**SOLICITATION AMENDMENT  
MODIFICATION DE L'INVITATION**

<b>Title - Sujet</b> CCGC Mechanical and Sprinklers	
<b>Solicitation No. - N° de l'invitation</b> EB144-190543/A	<b>Amendment No. - N° modif.</b> 010
<b>Client Reference No. - N° de référence du client</b> EB144-19-0543	<b>Date</b> 2018-08-16
<b>GETS Reference No. - N° de référence de SEAG</b> PW-\$PWA-121-5750	
<b>File No. - N° de dossier</b> PWA-8-80020 (121)	<b>CCC No./N° CCC - FMS No./N° VME</b>
<b>Solicitation Closes - L'invitation prend fin</b> <b>at - à 02:00 PM</b> <b>on - le 2018-08-21</b>	<b>Time Zone</b> Fuseau horaire Atlantic Daylight Saving Time ADT
<b>F.O.B. - F.A.B.</b> <b>Plant-Usine:</b> <input type="checkbox"/> <b>Destination:</b> <input checked="" type="checkbox"/> <b>Other-Autre:</b> <input type="checkbox"/>	
<b>Address Enquiries to: - Adresser toutes questions à:</b> Russell (PWA), Alex	<b>Buyer Id - Id de l'acheteur</b> pwa121
<b>Telephone No. - N° de téléphone</b> (902) 401-8180 ( )	<b>FAX No. - N° de FAX</b> (902) 496-5016

*This Addendum and all Addenda amends and forms an integral part of the Bidding and Contract documents and shall be read in conjunction with the same.*

# HVAC PIPING SCHEMATIC – MECHANICAL ROOM FF111A 6

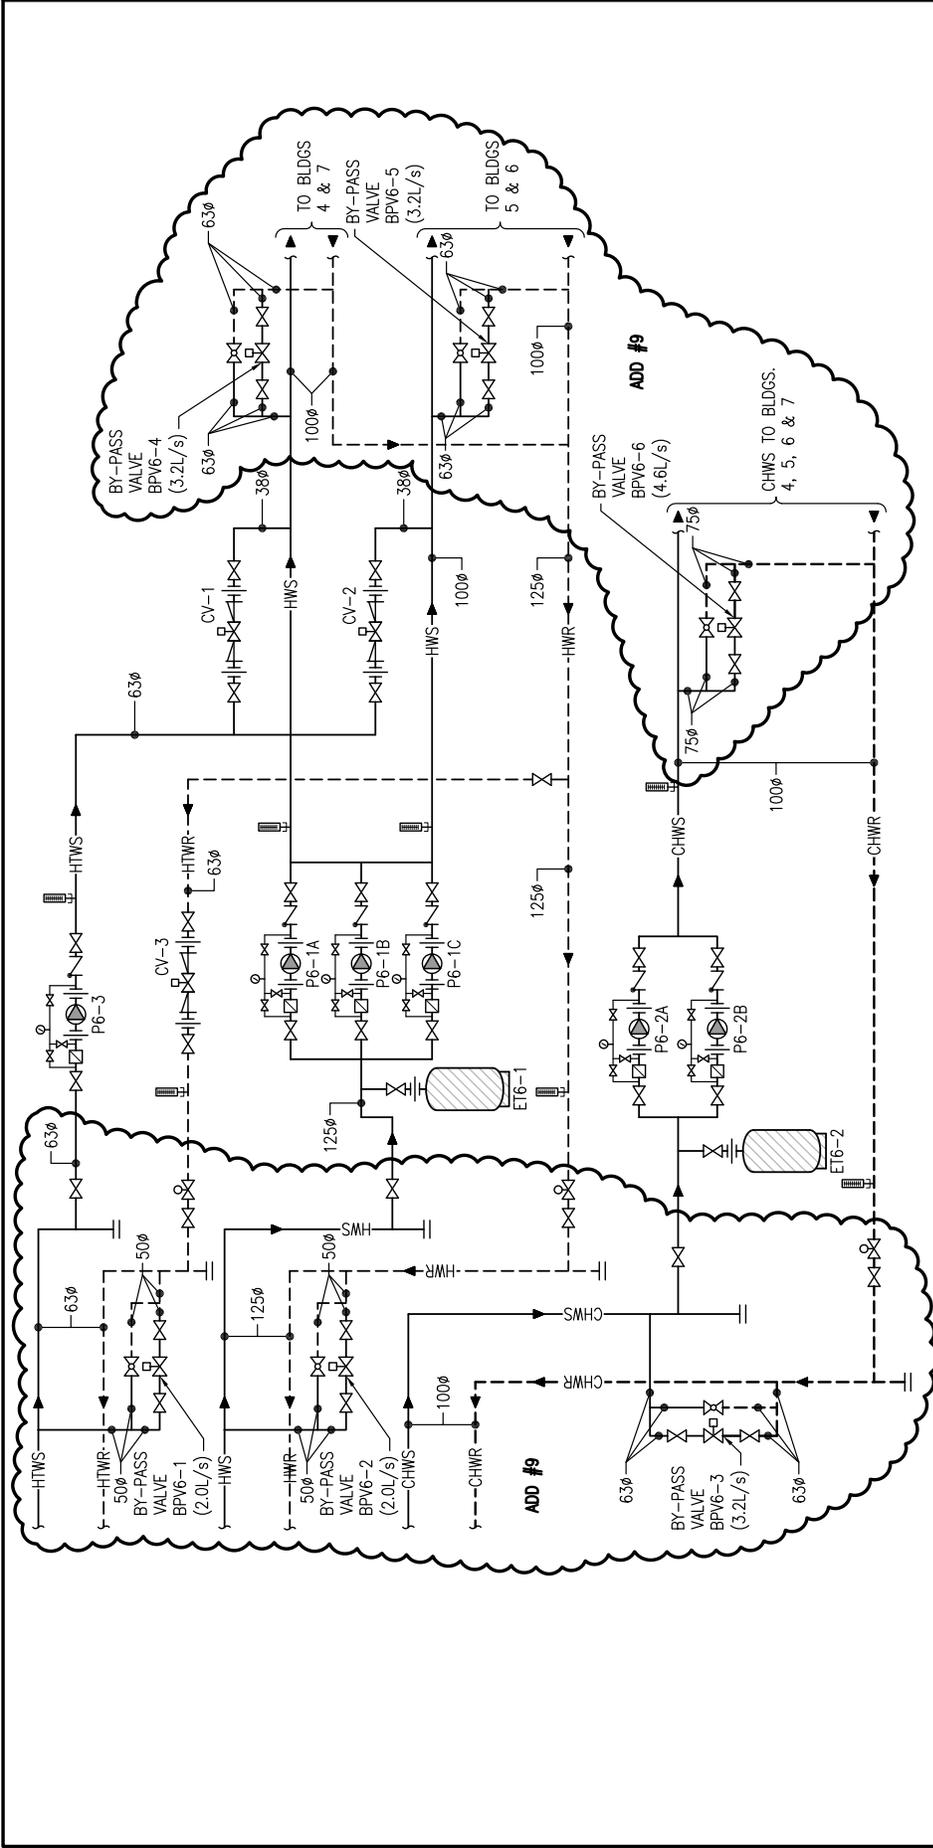
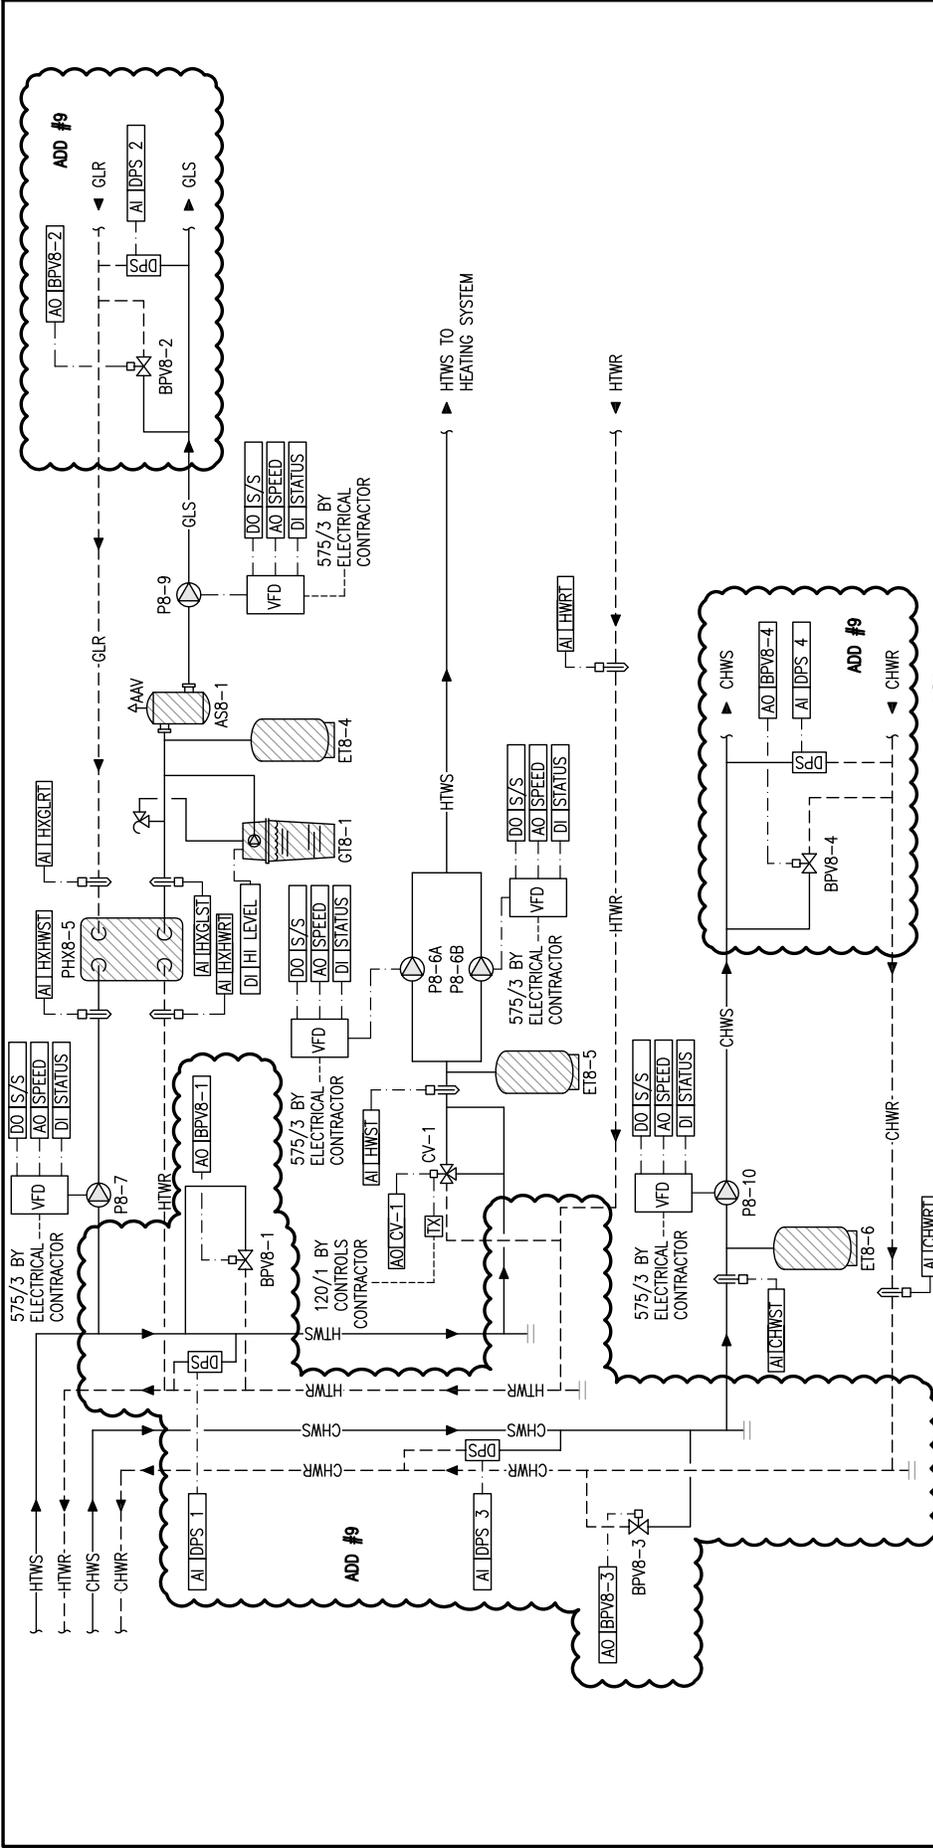
- .1 Detail 6: Revise HVAC piping in mechanical Room F111A as per Sketch 06-MH-SK007 (this addendum).

- .1 Detail 6: Revise HVAC Piping Schematic -Mechanical Room F110 per Sketch 06-MH-SK007 (this addendum).
- .2 Replace detail 3 *Vertical Inline Pump Detail* with *Typical Pad-Mounted Detail for Vertical In-Line Pumps with VSDs* detail. (See detail 5, drawing 01-MH-502). Floor mounted pumps with speed drives shall be installed as per this detail.

**HVAC PIPING SCHEMATIC – MECHANICAL ROOM P109**

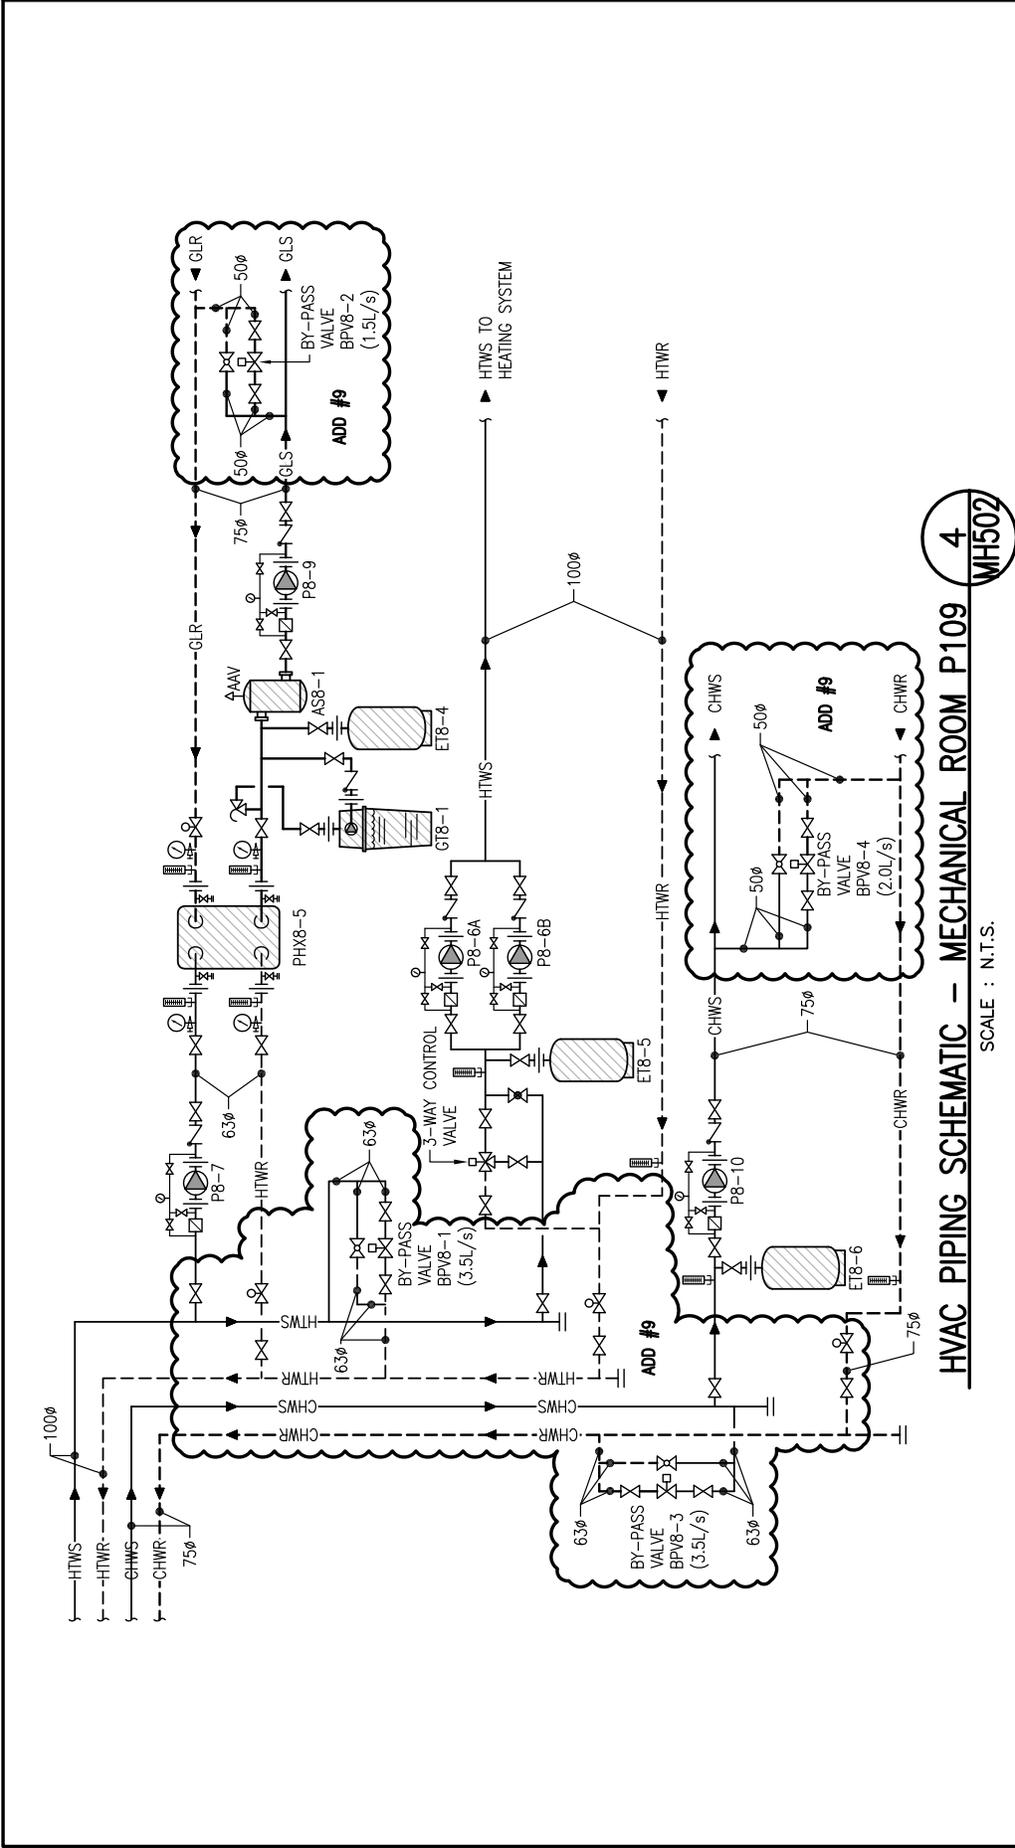
- .1 Detail 4: Revise HVAC Piping Schematic -Mechanical Room P109 per Sketch 08-MH-SK002 (this addendum).
- .2 Add *Typical Pad-Mounted Detail for Vertical In-Line Pumps with VSDs* detail to drawing. (See detail 5, drawing 01-MH-502). Pumps with speed drives shall be installed as per this detail.
